Montgomery County Department of Permitting Services  
Stormwater Management Structure  
Shop Drawing Review Checklist

PROJECT NAME: Clarksburg Town Center Sediment Control Permit #: 205466

S W M Structure: Water quality MH#4 S W M File #: 1-95042

STC 1200

DWG.# STC 1200-S

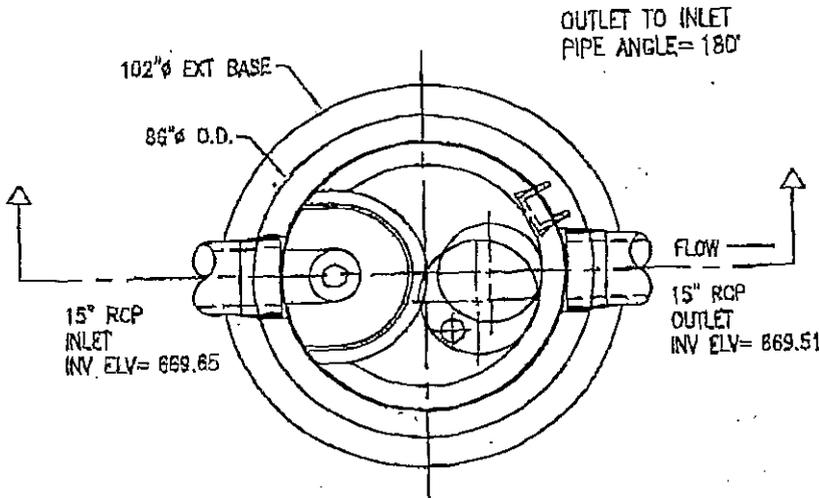
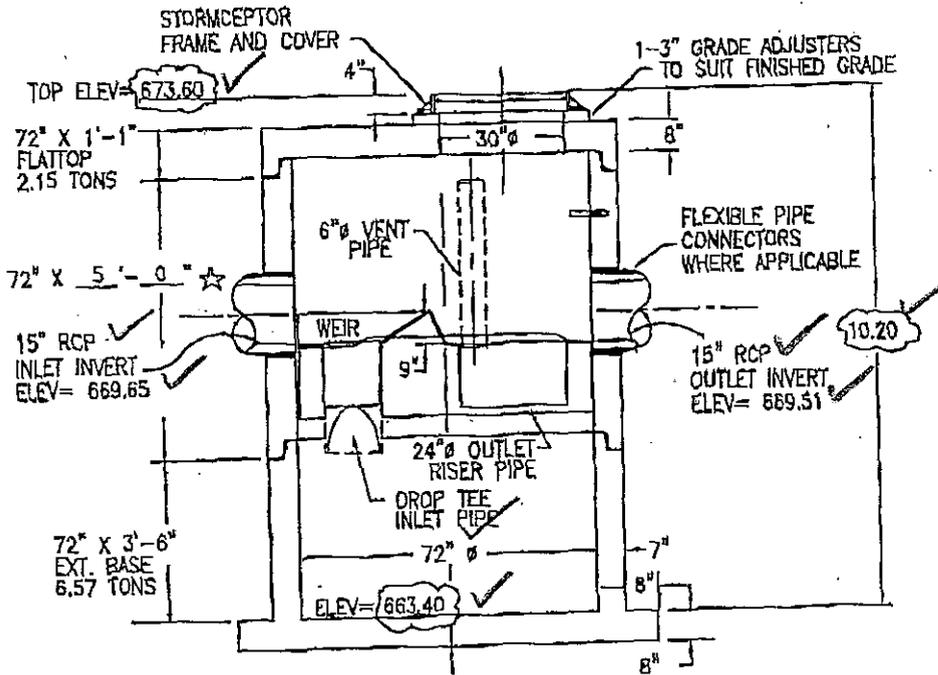
1	ADJUSTED TOP AND BOTTOM ELEVATIONS	BNG	02/09/05
REV.	DESCRIPTION	BY:	DATE
